**PUD &  
SUBDIVISION STAFF REPORT****Date: January 8, 2004****DEVELOPMENT NAME**

Norstedt Subdivision

REQUEST Planned Unit Development, Subdivision

# SITE PLAN

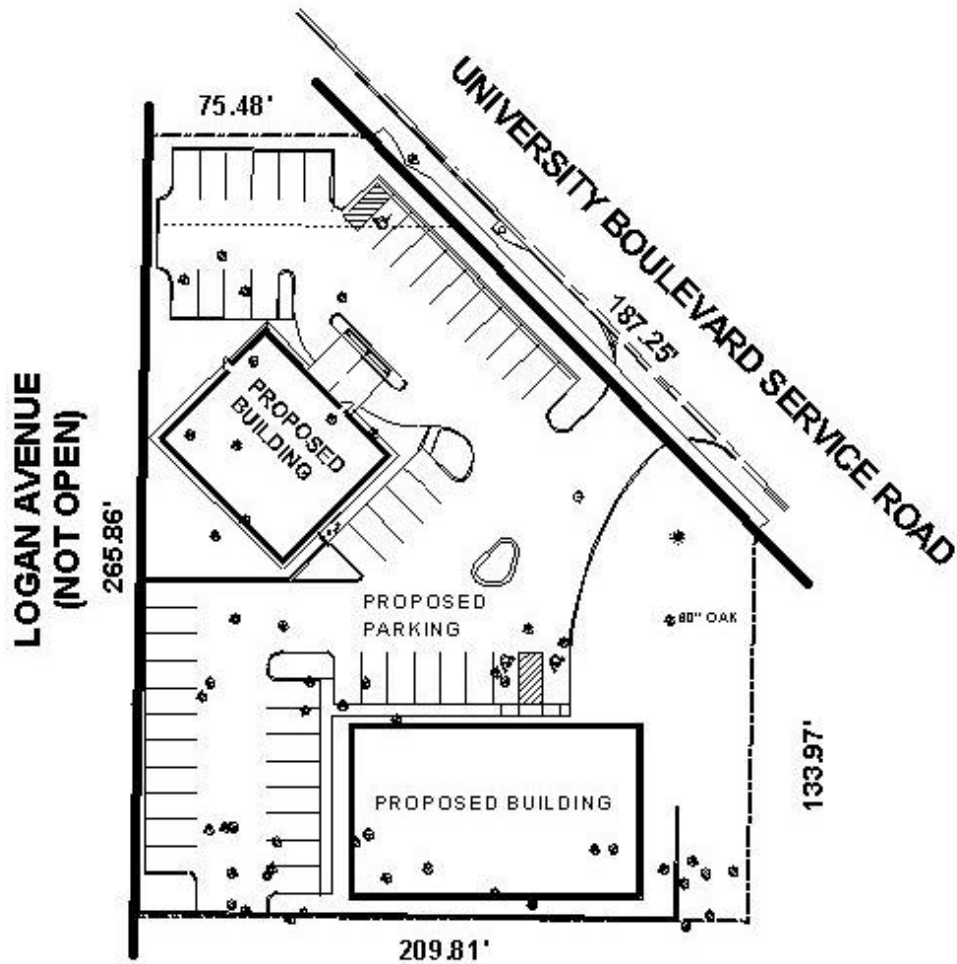
The first relates to the location of the building along the Southern lot line. The Zoning Ordinance requires a minimum 10' buffer strip when commercial property abuts residentially zoned property. As proposed, the building will be 6.78' from the property line. While PUD approval may allow reduced setbacks, it should not be used to reduce buffering requirements. In addition, as parking facilities are proposed in a portion of the required buffer strip, a 6' wooden privacy fence should also be provided along the South and East property lines.

Another point relates to the unopened Logan Avenue right-of-way adjacent to the West. This unopened right-of-way is an issue for two reasons. The first relates to setbacks. As proposed, one of the buildings is less than 5' from the Logan Avenue property line. The Zoning Ordinance requires a minimum setback of 20' from a side street property line when the property to the rear fronts on the side street.

The Subdivision now before the Commission does not reflect the vacation of the Logan Avenue right-of-way or the 7' alley. However, a vacation request for Logan Avenue has been submitted to the City and includes right-of-way South of the site in question. As submitted, that request has been recommended for denial because it would create a landlocked property (the lot immediately South of the property in question). Therefore, completion of the vacation process for the portion of Logan Avenue adjacent to the site should be required. Also, as the remaining portion of Logan Avenue would serve residential properties, access from this commercial development to Logan Avenue should be denied.

**Planned Unit Development:** based on the preceding, it is recommended that this application be approved subject to the following conditions: 1) completion of the Subdivision process prior to the issuance of any permits; 2) provision of the required 10' buffer strip along the South property line, and a 6' wooden privacy fence along the South and East property lines – where the site abuts residentially zoned properties; 3) completion of the vacation process for the portion of Logan Avenue that abuts this site; 4) the 60" Live Oak on the East side of the property (University Boulevard Service Road) is to be given preservation status (Any work around, including trimming or removal of this tree, requires approval from the Mobile Planning Commission.), all work under the canopy is to be permitted and coordinated with Urban Forestry; and 5) full compliance with all municipal codes and ordinances.

**Subdivision:** based on the preceding, the plat is recommended for Tentative Approval subject to the following conditions: 1) provision of the required 10' buffer strip along the South property line, and a 6' wooden privacy fence along the South and East property lines – where the site abuts residentially zoned properties; 3) completion of the vacation process for the portion of Logan Avenue that abuts this site; 4) placement of a note on the final plat stating that access to Logan Avenue is denied; and 5) placement of a note on the final plat stating that the 60" Live Oak on the East side of the property (University Boulevard Service Road) is to be given preservation status (Any work around, including trimming or removal of this tree, requires approval from the Mobile Planning Commission.), all work under the canopy is to be permitted and coordinated with Urban Forestry
